Village of Bratenahl  
411 Bratenahl Rd.  
Bratenahl, OH 44108

ARCHITECTURAL DESIGN AND REVIEW BOARD  
MEETING MINUTES

August 13, 2019

**Bratenahl Road Site Improvements**

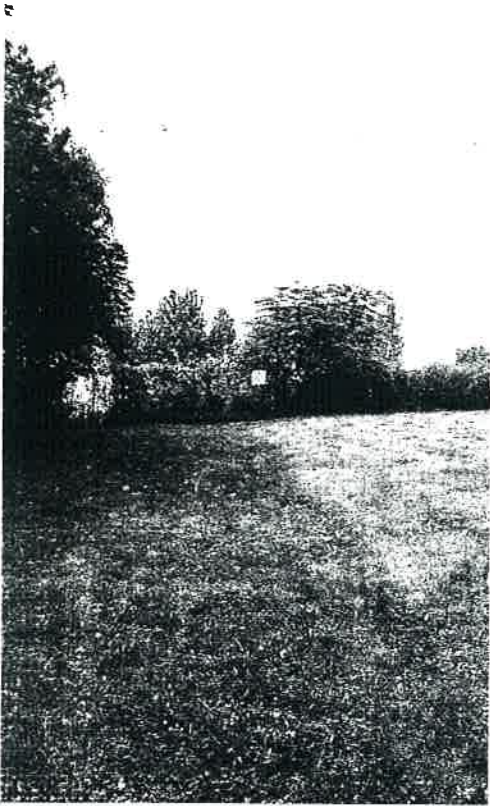
Mr. Don Bierut, Village Engineer, presented a plan for improvements to the north end of Bratenahl Rd. The plan included a 6 ft. high black steel fence with a wrought iron look and a 5 ft. gate. Proposed resin planters were indicated on the plan. Mr. Bierut explained that it was suggested to install planters in order to absorb energy from an errant car. Planting materials to be decided at a later date. He stated that the fence is to provide some security as well as provide the ability to view the lake and that there has been some dispute as to the height of the fence.

Ms. McGlinchy said that she had viewed the sight and noted a “dog leg” of 20-30 ft. and added that any height can be perceived as an obstruction. She asked about “view port holes” on a taller fence. Mr. Bierut said it was looked

Ms. McGlinchy suggested that the Village look into how the fence can be installed for the complete width of the property and tie into the west and east fencing without keeping the chain link dog leg installation to the west. She also suggested the plan be tabled.

Ms. McGlinchy stated that they will table the proposal until some items were reviewed and resolved:

- The “dog-leg” to the west -a straight tie-in is preferred
- Confirmation of height
- Foreground feature: bollards, planter, etc.
- Gate ornament

Ex. "A"

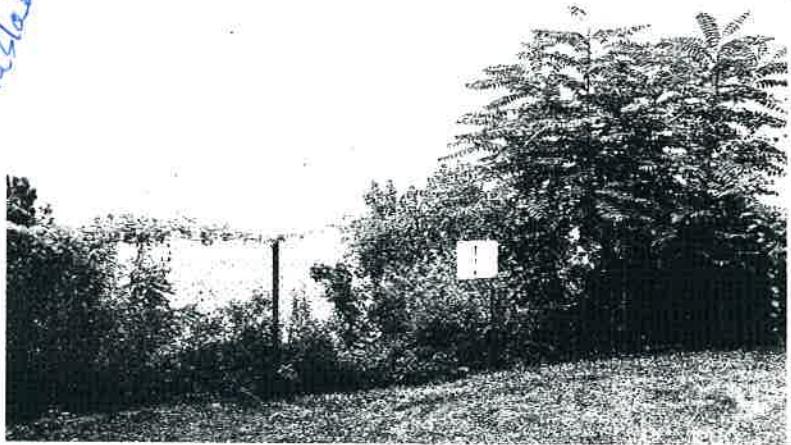
**PUBLIC COMMENT:** Ms. Sue Capello stated that she lived in the Village for 37 yrs. and the area in question was always referred to as Sunset Park. She attended five Public Improvement meetings, a lower fence was always discussed and council had approved 17K for Fence and Landscaping. She distributed a document of photos and a 4 ft. fence. (Exhibit A). She suggested that the Village install a 4 ft. fence to match the one on the east side of the property, attaching to the Lakehurst wall. She stated that this would provide the security that Lakehurst desires and a lower fence so that residents can view the lake.

West border  
Haslam's  
fence, top  
of hill to lake  
W → S

4 Ft fence  
E → W
